## STE-QUEST Preliminary Requirements Review (PRR) Technical Report

**Prepared by** STE-QUEST PRR Panel  
**Reference** ESA-STEQ-RP-0001  
**Issue** 1  
**Revision** 1  
**Date of Issue** 16/12/2013  
**Status** Approved/Applicable  
**Document Type** RE

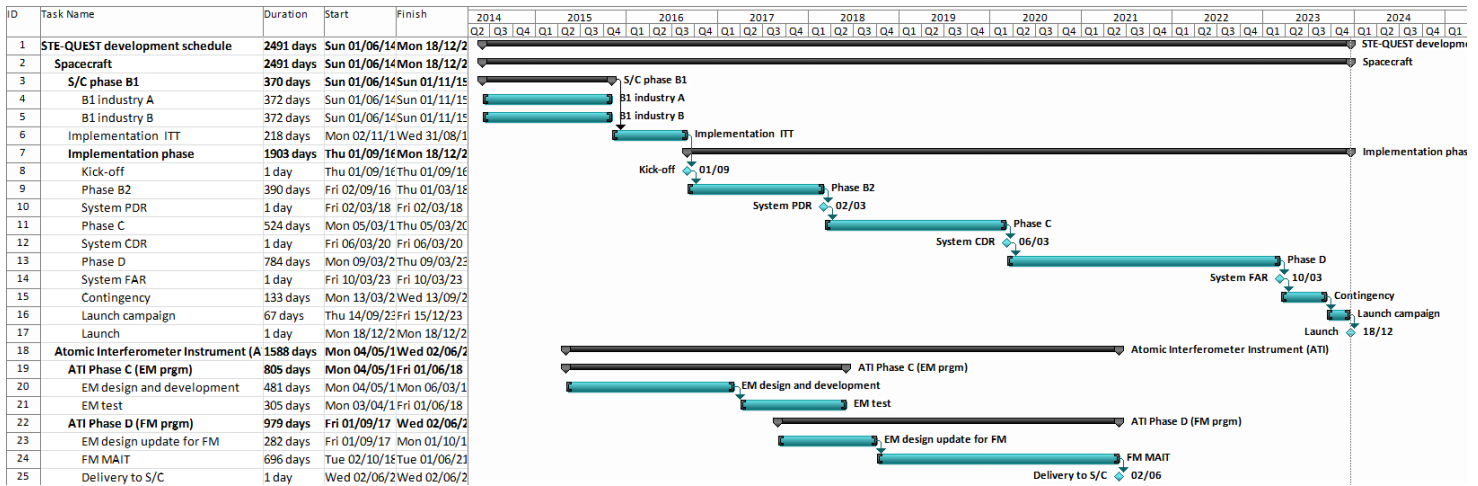
The panel considers the duration of phase B2 for Thales too short and the Astrium duration of B2 marginal for a thin prime approach.

At satellite level, the time available to perform the AIT on the complete satellite (i.e. service module and payload module) is rather limited and, especially in the Thales case, not judged sufficient.

The overall schedule contingency margin with respect to a launch date in 2022 presented by the Astrium study team is judged too small, even without taking into account the suggested additional slack in the payload schedule. The schedule margin of 6 months presented by TAS is considered not credible since it is based on an earlier (and hence not very realistic) need date for the payloads and it includes an increased schedule risk due to early start of activities (for instance start of PFM manufacturing and AIT activities before finalization of ATB verification activities). The TAS duration of Phase C/D is thus judged too short.

In consideration of what stated above on the P/L and satellite schedules, the panel considers the launch date of 2022 not realistic.

A launch date in June 2023 is considered the earliest credible launch date, to be confirmed by a detailed analysis of updated P/L development and test plan and of S/C development schedule. This date is success oriented, in that it is based on the assumption of early availability (starting in phase B1) of funding for the payload elements from Member States and successful technology development activities. Adding the 6-month contingency between FAR and Launch brings the launch date to December 2023, as indicated in the schedule below.
